**PEDESTRIAN HEART
DARLINGTON**

ROAD SAFETY ASSESSMENT REPORT

Road Safety Assessment

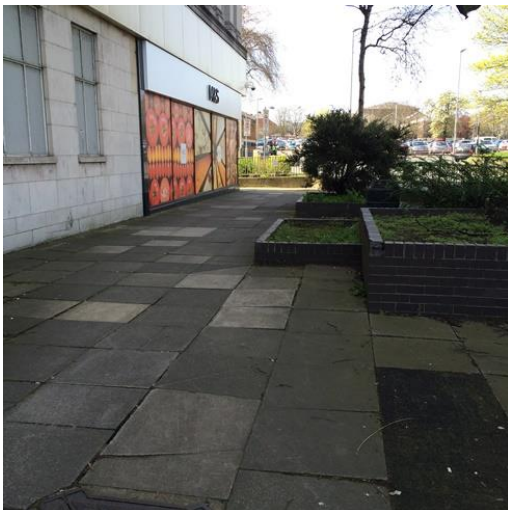
Location: East of Northgate.

Summary: Increased risk of pedestrian/pedal cycle conflict due to width of existing footway.

Description: There are several locations east of Northgate where the proposed off carriageway route for cyclists narrows. The proposed prohibition of pedal cyclists is likely to increase the numbers travelling along the footway to navigate around the town centre. The lack of width of the proposed shared route may increase the risk of pedestrian/pedal cycle conflict.

Recommendation: Ensure the shared area along this section of St Cuthbert's Way is sufficiently wide enough to accommodate both pedestrians and cyclists.
